## General Information

A new design for the S2 grille went into production on February 5, 2018. The hood design has also changed slightly to accommodate a different grille fastening strategy. The old grille and hood part numbers will no longer be produced, and will supersede to the new design with new part numbers.

## Freightliner Custom Chassis Service Bulletin

Walk-In Van  
> S2

**Fig. 1, Grille Installation**

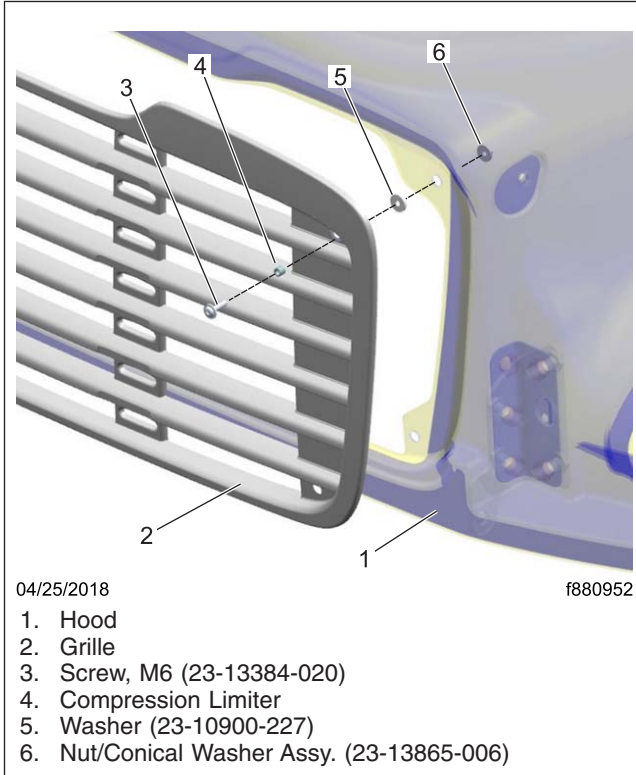
To replace a grille on a hood from a vehicle built prior to February 5, 2018, the additional fasteners shown in [Table 1](#) must be used. See [Fig. 1](#) and [Fig. 2](#). Parts are available at the PDCs.

1. Park the vehicle on a level surface, shut down the engine, and set the parking brake. Chock the tires.
2. Remove the four screws that attach the grille to the hood, and discard them.
3. Remove the isolated nuts from the hood, and discard them.
4. Install the new grille, with the new washers between the grille and the hood, then attach it to the hood with the new screws and nut/conical washer assemblies. Tighten the nuts 60 to 84 lbf-in (680 to 950 N-cm).
